Please find attached the comments of the Broadway Hollywood Homeowners Association regarding the Hollywood Center Draft EIR.

RE: Public comments on the Hollywood Center EIR

Hollywood Center Project Environmental Case: ENV-2018-2116-EIR State
Clearinghouse No.: 2018051002

Specific Issue: The Broadway Hollywood Building Existing/Simulated

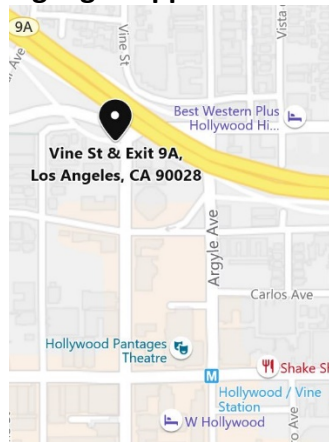
Views: EIR Figure View below is from grade point of view from Broadway Hollywood Building location looking north. There are additional visual impacts to review:

View looking south from the 101 freeway (a scenic highway) vine Exit 9A. The view of the Historic Building and Sign are iconic and a significant historic view is from the 101 freeway and at the exit elevation as one enters through the Hollywood gateway into the historic district and the iconic corner of Hollywood and Vine. The analysis shows existing/proposed views that are slightly east or west in the photos and

do not capture the view of the Broadway Hollywood Building that exists. **This project will irreversibly reduce the importance of the Broadway Hollywood building and historic neon rooftop sign as an individual historic feature and as a contributor to the aesthetic character of the Hollywood Boulevard Commercial and Entertainment District. This meets potential aesthetics impact with a *Threshold (a) Would the Project substantially damage scenic resources, including but not limited to trees, rock outcroppings, and historic buildings within a City designated scenic highway?***

In addition to the building itself, the Broadway Hollywood Neon Rooftop sign is a historic sign that is a historic feature of the building and can be seen from the scenic highway. Blocking this vista requires specific compliance review under this EIR analysis and for impacts to the Broadway Hollywood Rooftop Neon Sign under the Hollywood Signage Supplemental Use District.

Figure 1: Bird's Eye view of only vehicle access point

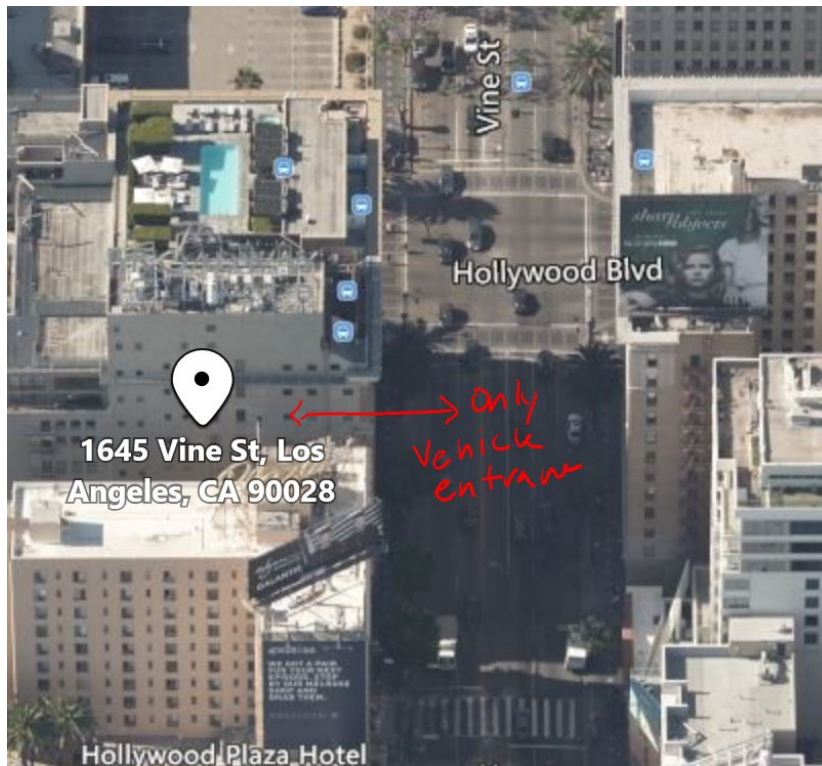
Specific Issue: Broadway Hollywood Ingress/Egress:

The N-2 LADOT Correspondence dated April 10, 2020, from the City Approving the Traffic study in the EIR, rates the intersection of Hollywood and Vine as an “F” during am/pm for 2027 projections. There is no Neighborhood Traffic Management Program analysis, nor project features, traffic signal analysis, or mitigation specifically address the significant impacts to unique to the Broadway Hollywood Building. The anticipated added traffic (vehicle and pedestrian) will create undue congestion and during operations and once the project is complete will significantly limit or restrict ingress and egress to the only vehicular entrance servicing the 96 live/work units. An updated impact analysis must be conducted to determine if the impacts of this project would pose life, safety, or a government taking of access (ingress/egress) to a private property of all individual (96) unit owners.

The only vehicle entrance for all building parking is located on vine through an alley between the building and the Hollywood Plaza building. Increased pedestrian or added traffic will block the only entrance to building parking. Taking access and/or increasing the burden of access to this building is a significant impact. There is no left turn into this alley, thus there is only one-way access from Vine traveling south. Pedestrian flow impacts the ability for vehicles to enter or exit the alley onto the street.
